Access Compliance Report

Public Rights-of-Way

Intersection ID: 21831	Main Street: ENGLAND_ST	Cross Street: WINDSOR_OAK_CT	Location: SE
ADA ID: 47A227642FBD	Ramp Type: PerpDiag	Initial Pass/Fail: Fail	Overall Compliance: No
Severity Score: 37.5			
Codes/Mitigation Info/Possible Solution		Field Measurements/Component Compliance

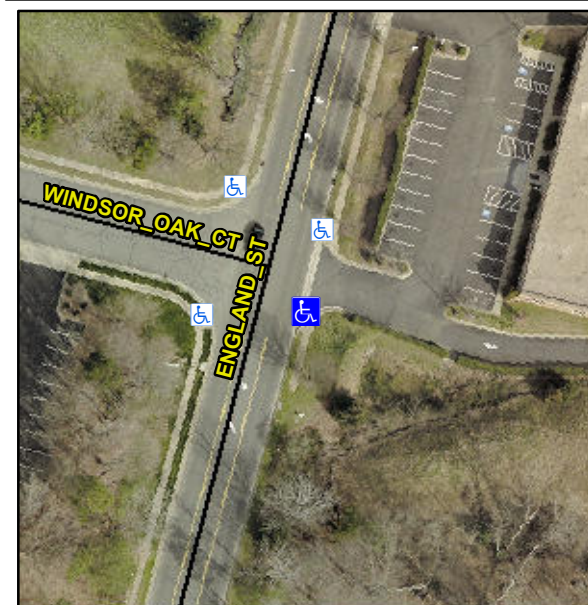
R304.2.2, R304.5.3

Compliance	Description	Data	Compliance	Description	Data
N/A	Ramp Length (in)	50.5	No	Ramp Slope (%)	9.4
Yes	Ramp Width (in)	48.0	No	Ramp XSlope (%)	11.1
N/A	Flare Type LT	N/A	N/A	Flare Type RT	N/A
N/A	Flare Slope LT (%)	N/A	N/A	Flare Slope RT (%)	N/A
N/A	Flare Traversable LT?	N/A	N/A	Flare Traversable RT?	N/A
N/A	Landing Length (in)	N/A	N/A	DWS Provided?	N/A
N/A	Landing Width (in)	N/A	N/A	DWS Contrast?	N/A
N/A	Landing Slope (%)	N/A	N/A	DWS Length (in)	N/A
N/A	Landing X Slope (%)	N/A	N/A	DWS Full Width?	N/A
N/A	Landing Curb? (Y/N)	N/A	N/A	DWS Offset (in)	N/A
N/A	Shared Landing?	N/A			
N/A	Gutter Ponding?	N/A	N/A	Gutter Slope (%)	N/A
N/A	Gutter Lip Ht (in)	N/A	N/A	Gutter X Slope (%)	N/A
N/A	Painted X Walk1?	No	N/A	Painted X Walk2?	No
	X Walk 1 Direction	To NE		X Walk 2 Direction	To NW
N/A	X Walk 1 Width (in)	N/A	N/A	X Walk 2 Width (in)	N/A
	X Walk 1 Slope (%)	4.1		X Walk 2 Slope (%)	4.3
	X Walk 1 X Slope (%)	6.4		X Walk 2 X Slope (%)	2.9

Remove & Replace Curb Ramp With Two New Directional Ramps or Equivalent.
